ADDENDUM NO. 2

PROJECT NAME: **CESAR CHAVEZ PARK PERIMETER PATHWAY
IMPROVEMENT PROJECT**

SPECIFICATION NO.: **25-11702-C**

DATE: **APRIL 10th, 2025**

SHEET No. **X-1**

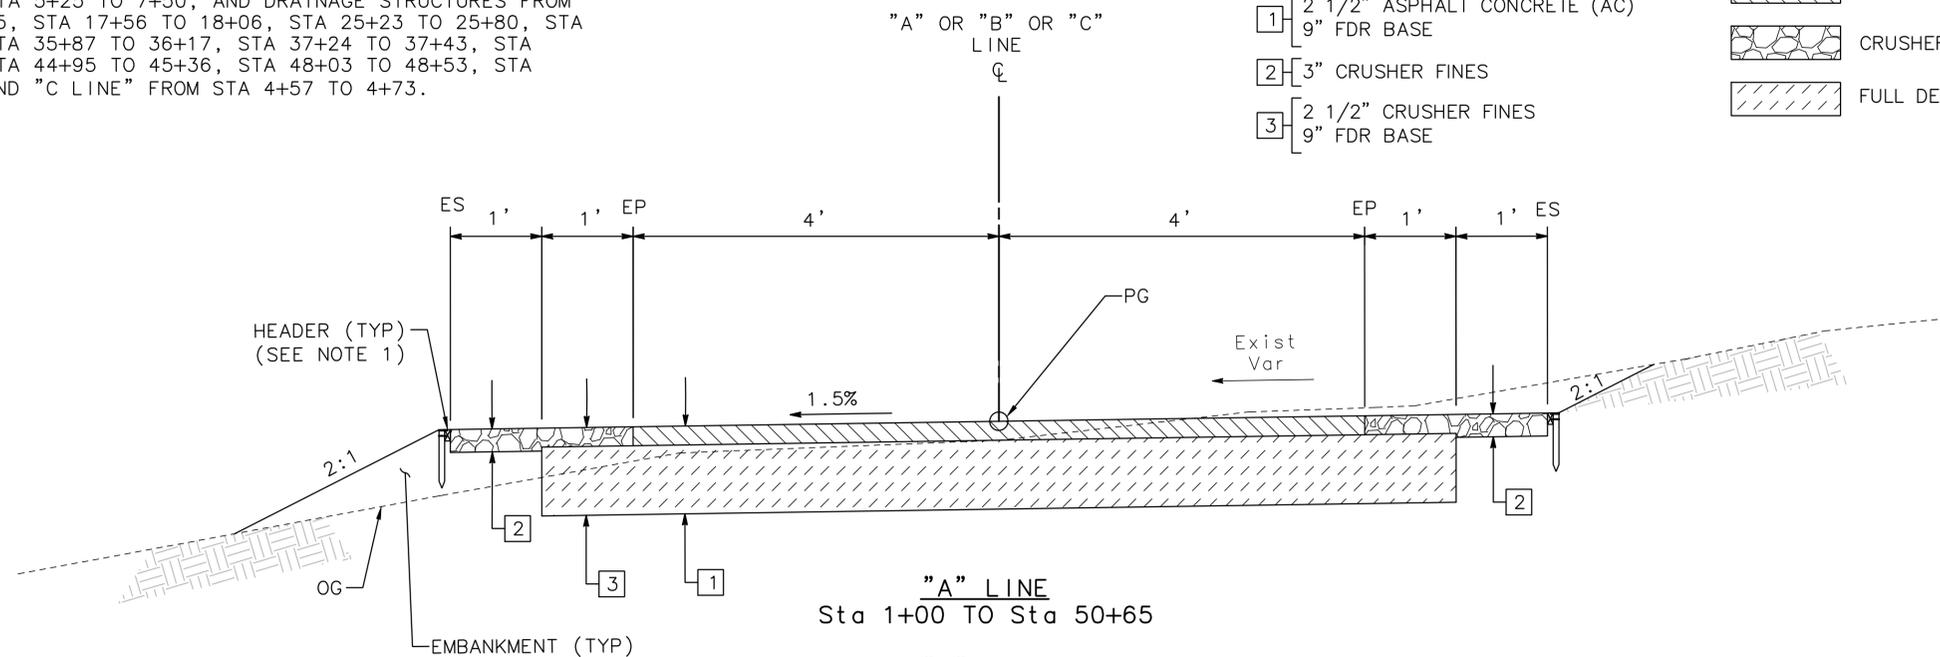
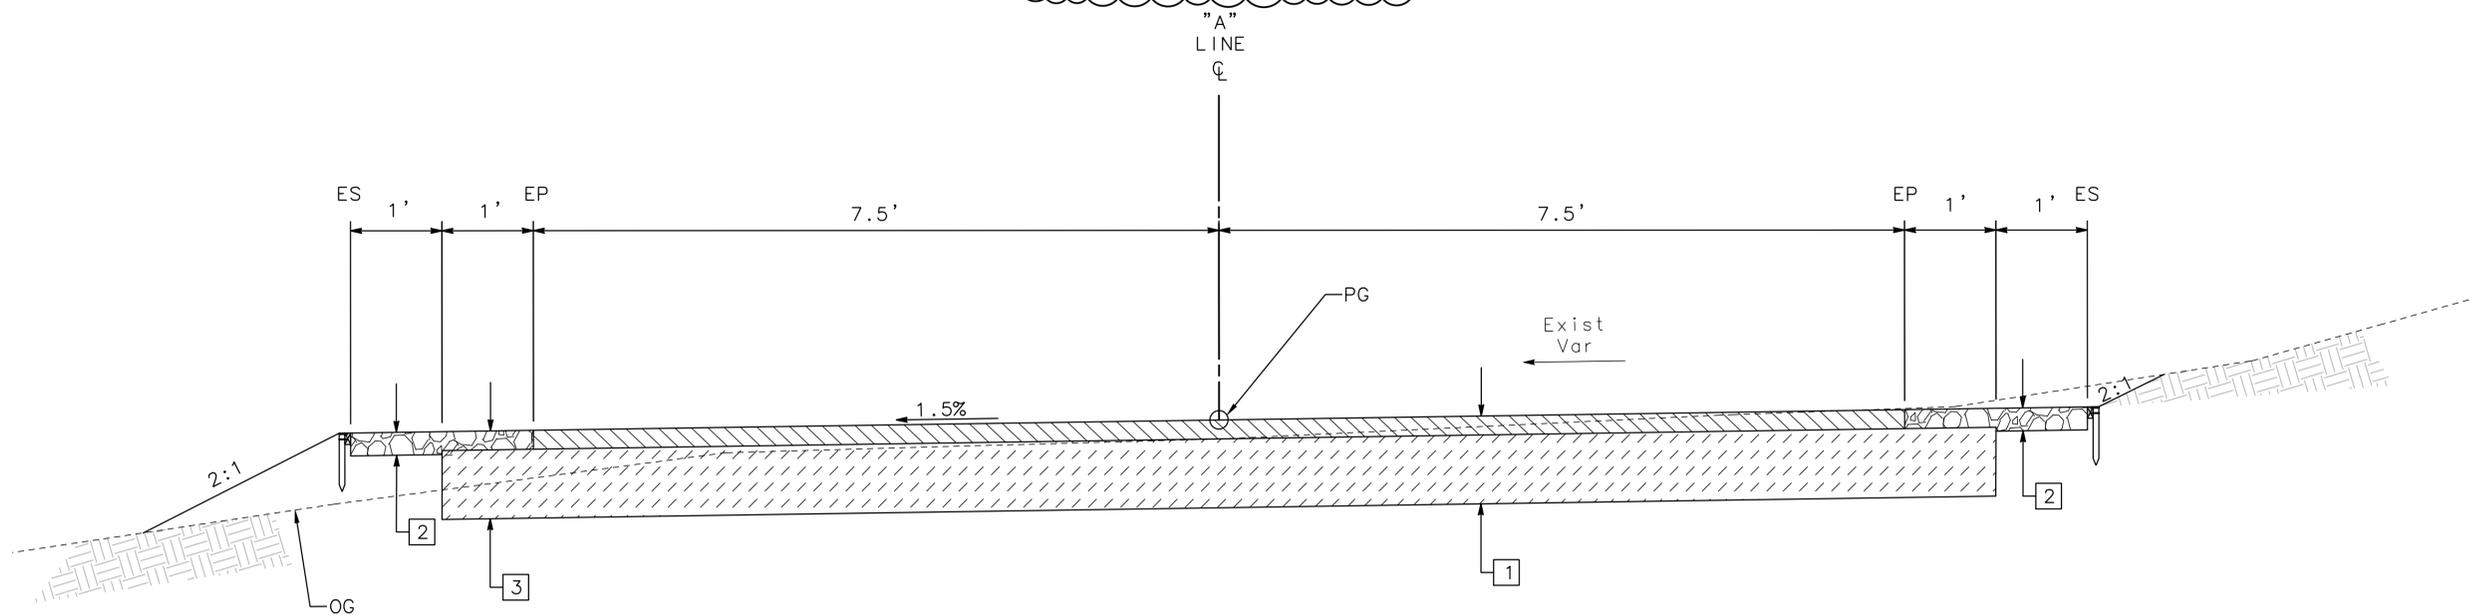
1. **Plans:** Cesar Chavez Pathway Improvement Project – Final Plans.
REPLACE with attached revised Sheets T-1 and X-1.
 - Update Phase and “D” Line Description.

11. Can the City provide cross sections of the trail for accurate earthwork quantities?

Response: The City confirms the quantity of 2,110 CY for Bid Item No. 15 – Full Depth Reclamation (FDR). Please note, FDR extends 1’ beyond the existing edge of pavement as shown in Typical Sections X-1.

Response: Typical Cross Sections are shown on Sheet X-1 in the Plans. The City will not provide additional cross sections.

SHEET NO.: L-1

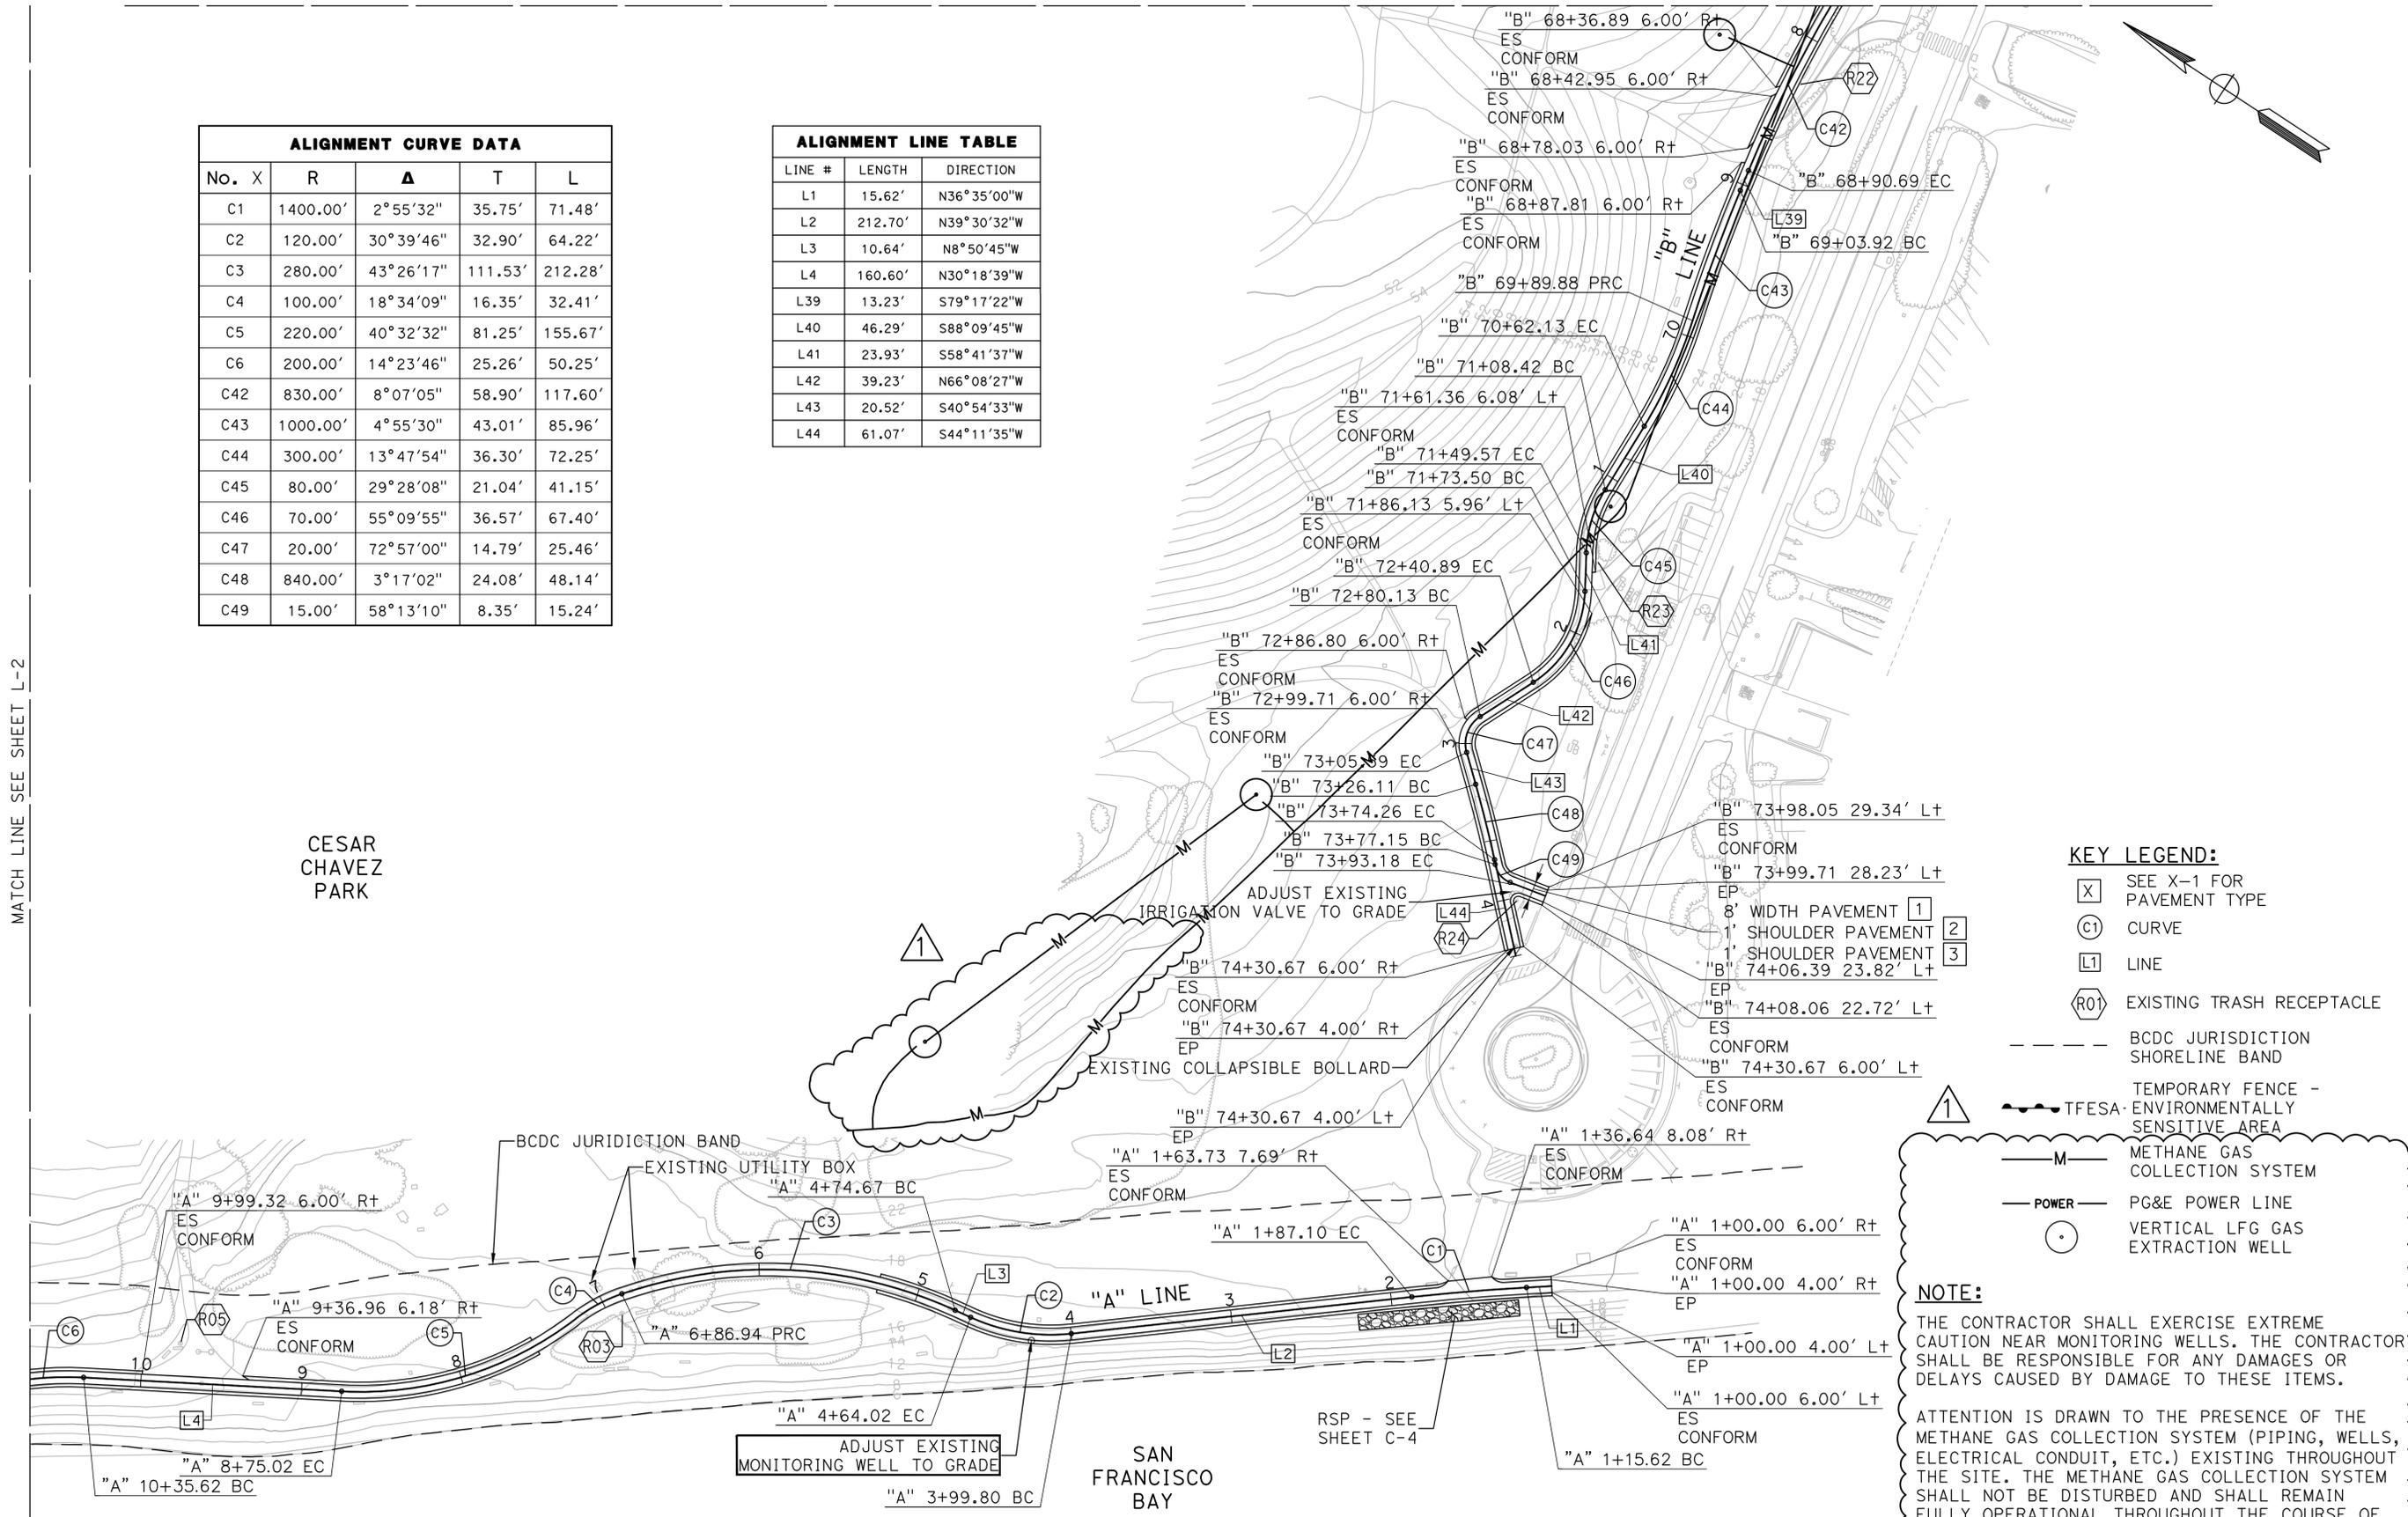
2. **Plans:** Cesar Chavez Pathway Improvement Project – Final Plans.
REPLACE with attached revised Sheets L-1, L-2, and L-4.
 - Update Methane Gas Collection System information and Storm Drain Access Hole Note.

TOTAL SHEETS: 21
 FILE No.: SCC 22-155
 SHEET No.: P-3

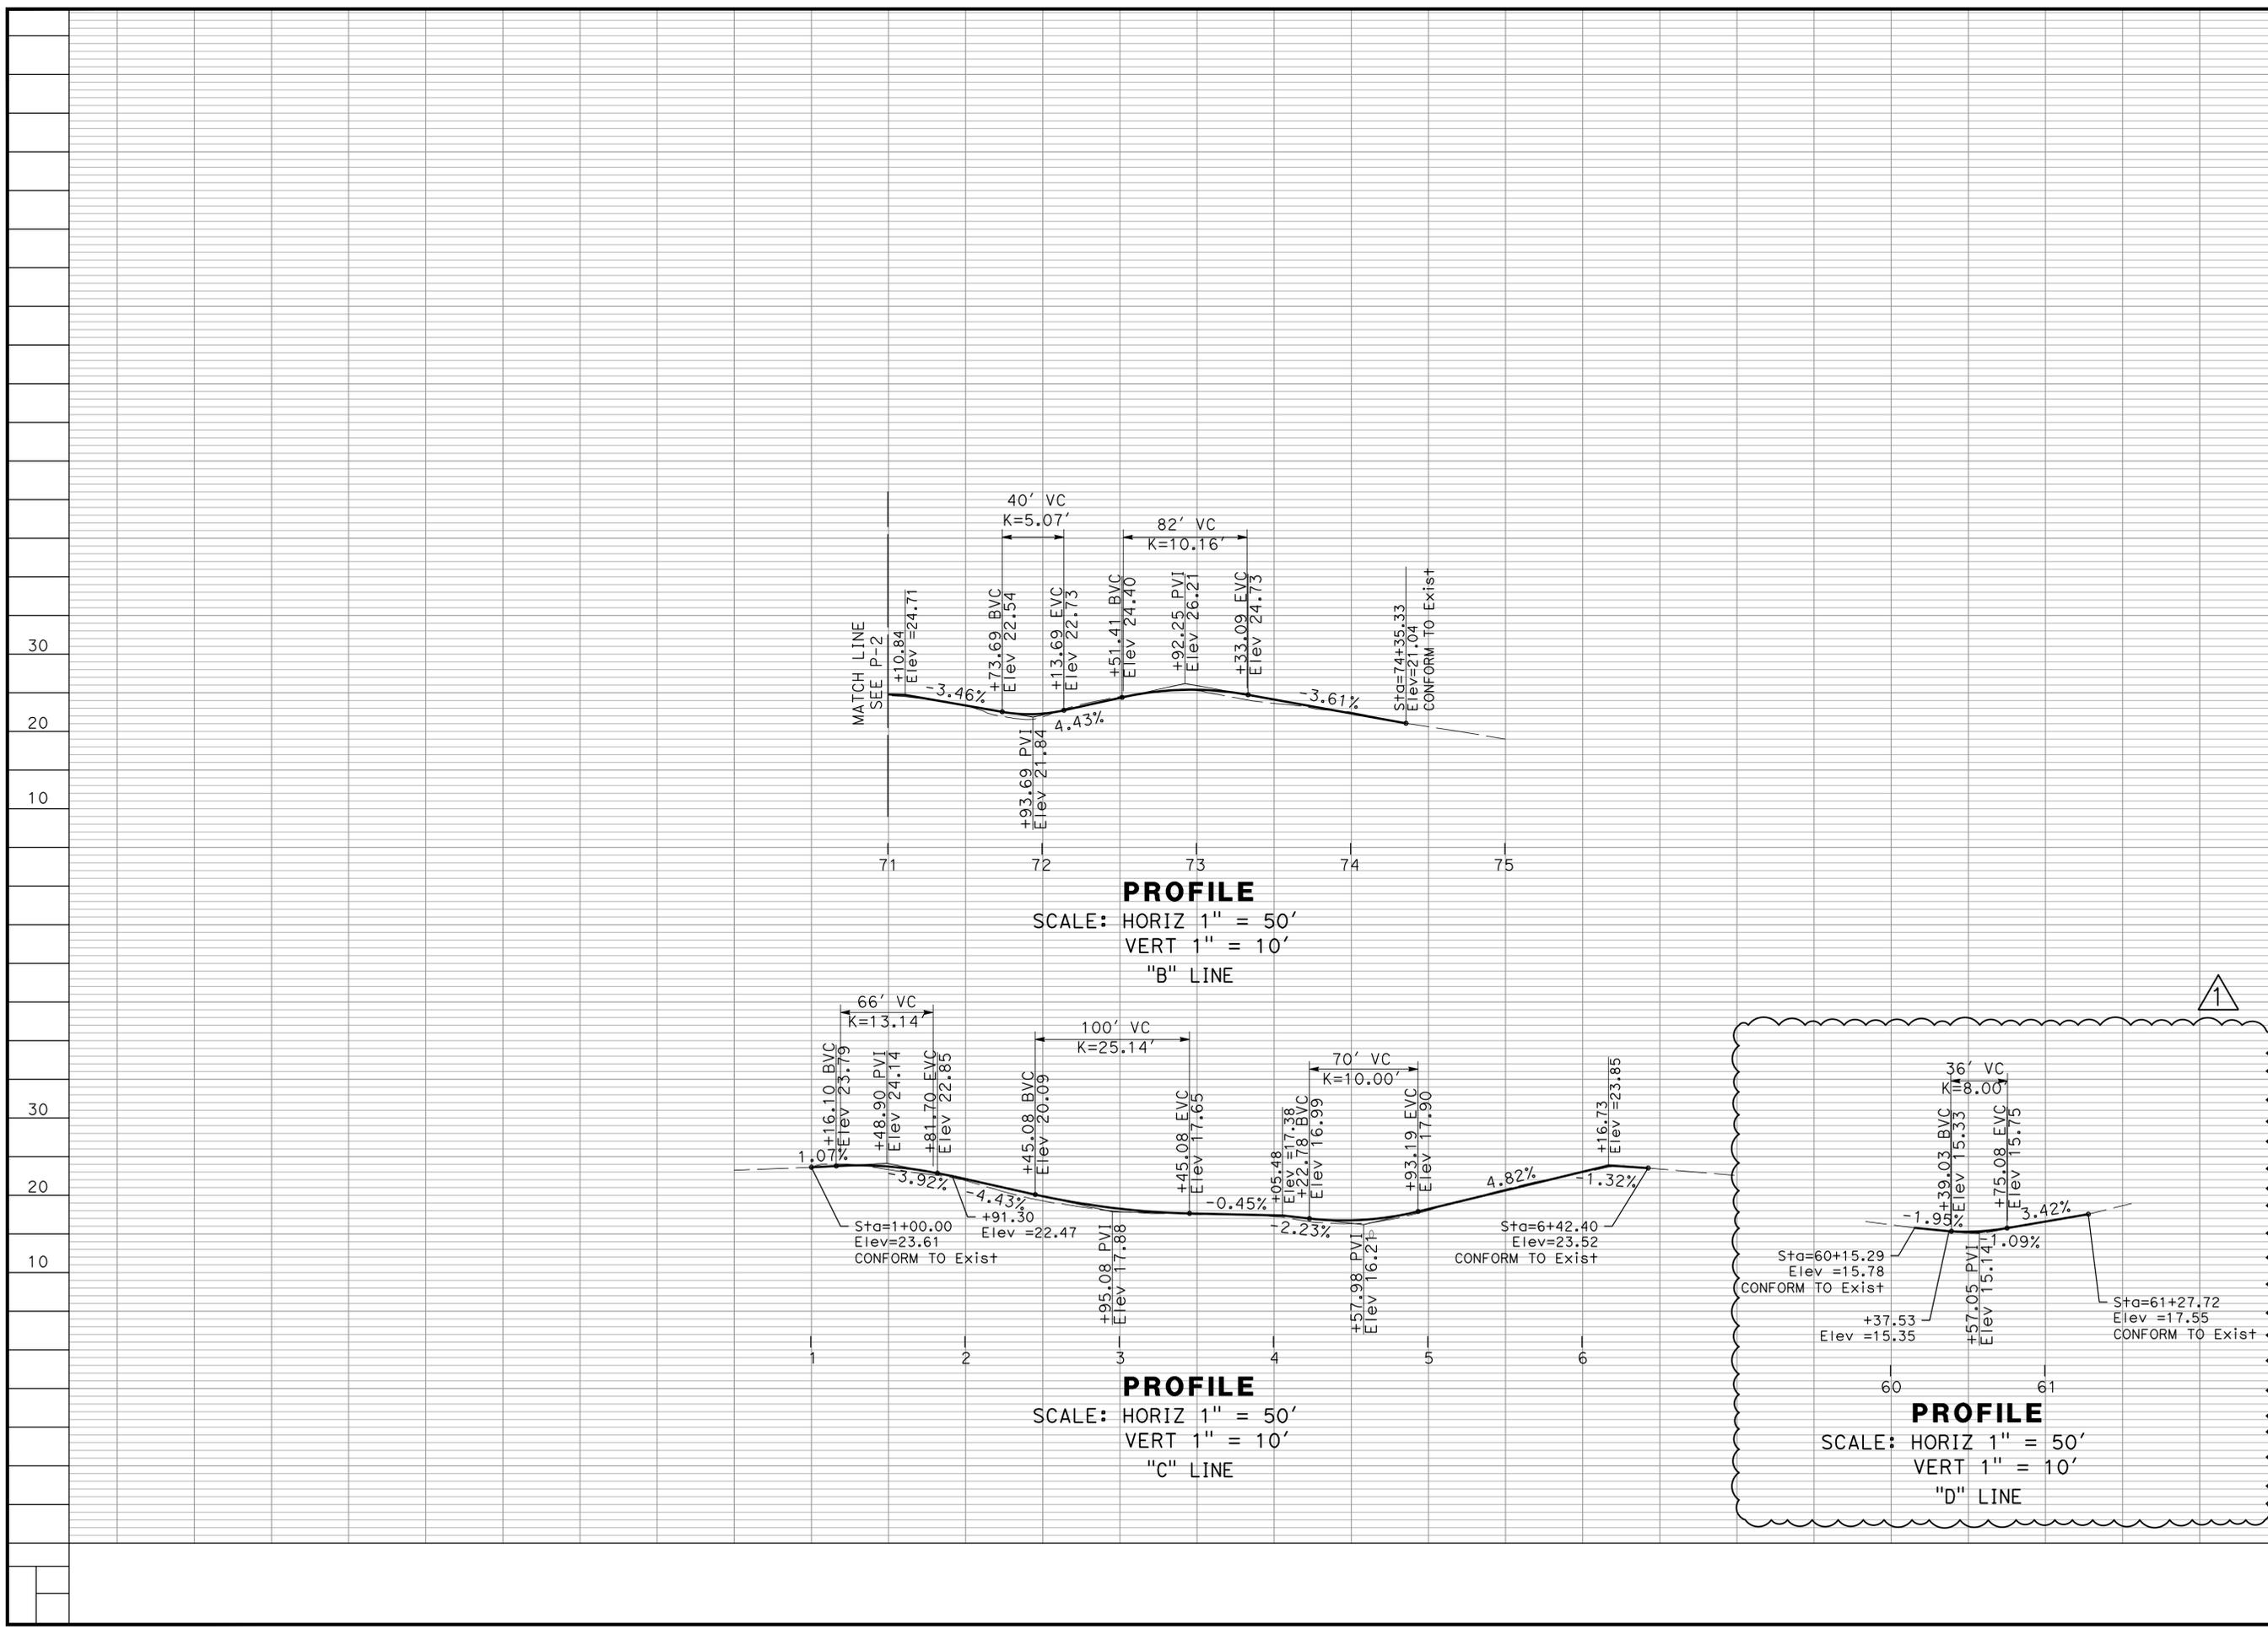
3. **Plans:** Cesar Chavez Pathway Improvement Project – Final Plans.
REPLACE with attached revised Sheet P-3.
 - Added “D” Line Profile.
4. **Plans:** Cesar Chavez Pathway Improvement Project – Final Plans.
REPLACE with attached revised Sheet C-3 through C-6.
